RE: NHTSA Recall 08E-016, Hyundai Recall 082

Subject: Campaign 082 – 2007/2008 Santa Fe and Veracruz Models – Trailer Wiring Harness Replacement

Subject **TRAILER HITCH WIRING HARNESS REPLACEMENT PROCEDURE (CAMPAIGN 082)**

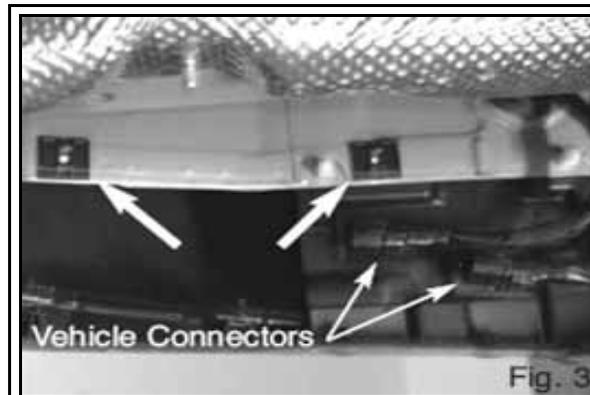
4. Remove the tow hitch control module and harness by grasping the module by the hand and gently rotating it back and forth until the adhesive separates from the bumper reinforcement.

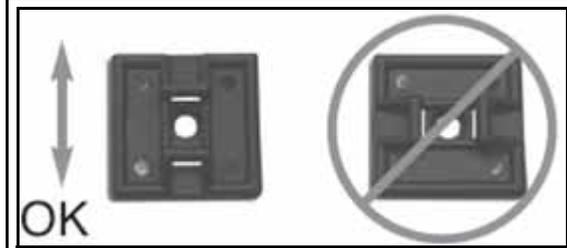
NOTE: The new module can be identified by the external fuse holder.
